AEROPRAKT

SERVICE BULLITEN

No. SB A-32-04

Model: A-32

Fig.1

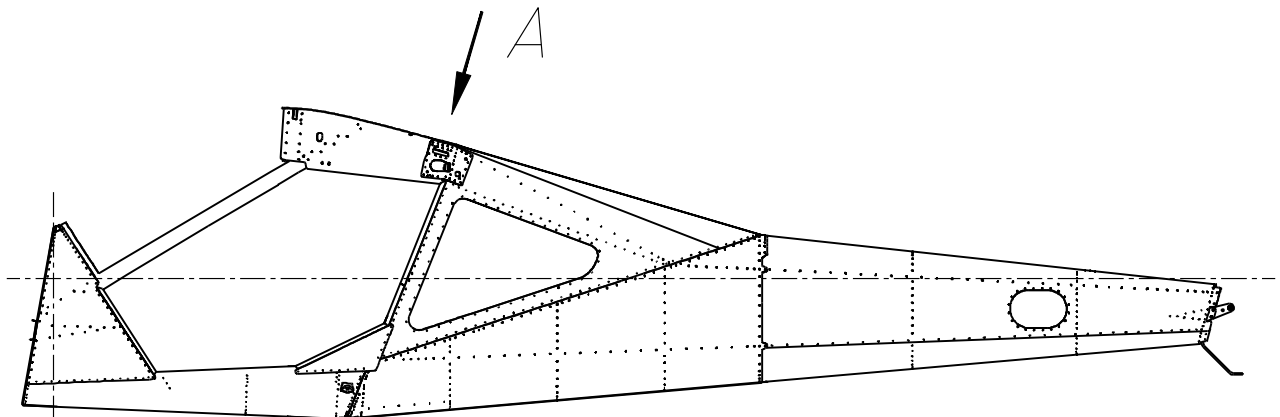
- 3.1) Inspect the rivet joint of the roof panel and frame No.3 (Fig.1, 2, 3), check number of the rivets (intervals between them) and their condition.
- 3.2) If number of the rivets (intervals between them) are as shown in Fig.3 and the rivets are not loosened, this repair work is not needed.
- 3.3) If number of the rivets (intervals between them) are as shown in Fig.2 and the rivets are loosened, this repair work must be accomplished.
 - 3.3.1) Mark and drill with $\varnothing 3.1$ mm drill bit the holes for additional rivets according to Fig.3.
 - 3.3.2) Insert and set the additional $\varnothing 3 \times 8$ rivets.
 - 3.3.3) Undrill the loosened rivets with $\varnothing 3.1$ mm drill bit and install the new $\varnothing 3 \times 8$ rivets.
 - 3.3.4) Paint the rivet heads with color of the airplane.
